CONSTRUCTION SUMMARY				
Mountainview Heights (G) - Russell Gardens Building Ltd.				
PURCHASERS: DORIN I BASARABA and MIOARA C BASARABA			TEL: RES.: 905-334-8261 BUS.: 905-257-0176	
LOT / PHASE	REG. PLAN #	HOUSE TYPE		
174 / 2	62M-1238	Rosewood 2 Elev 3

ROSEWOOD 2
2,728 sq.ft.

REAR UPGRADED ELEVATION 3
WITH WALK OUT CONDITION
LOT 174

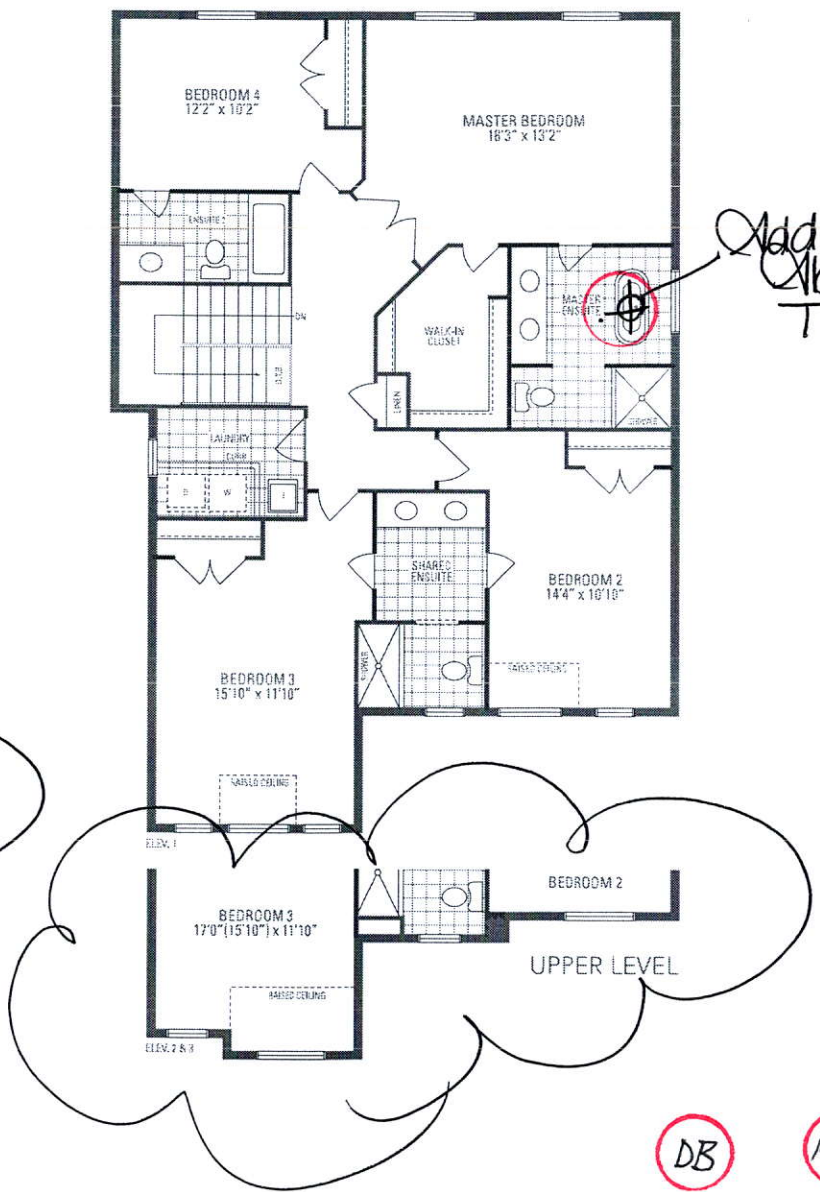
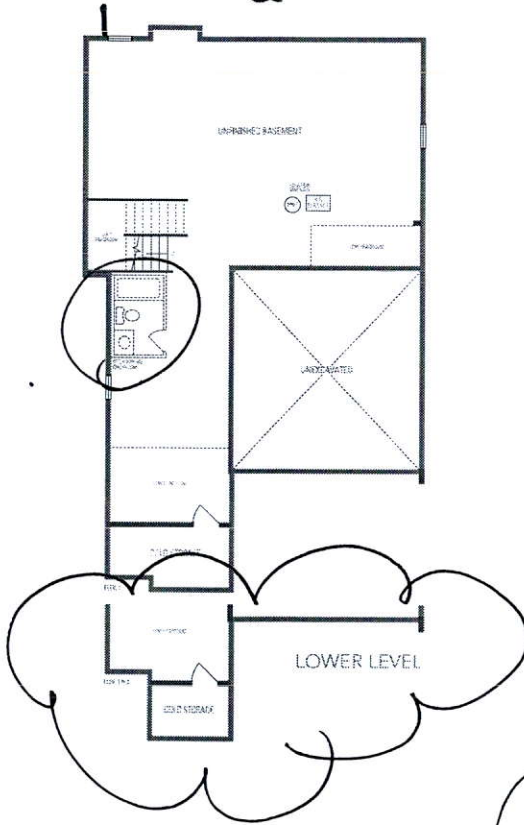
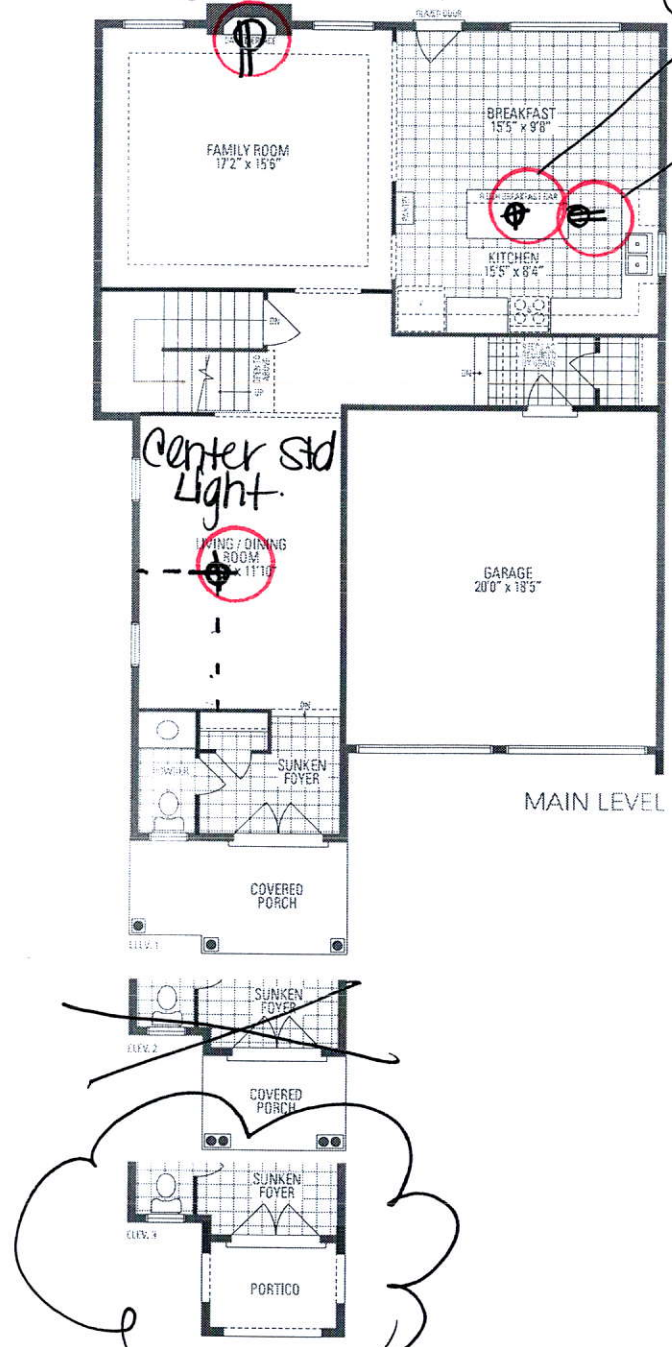
Add Plug Above Fireplace

Add Light Above Island
Add Plug on Island

Has Line R.1
for BBQ.

Add Light
Above
Tub.
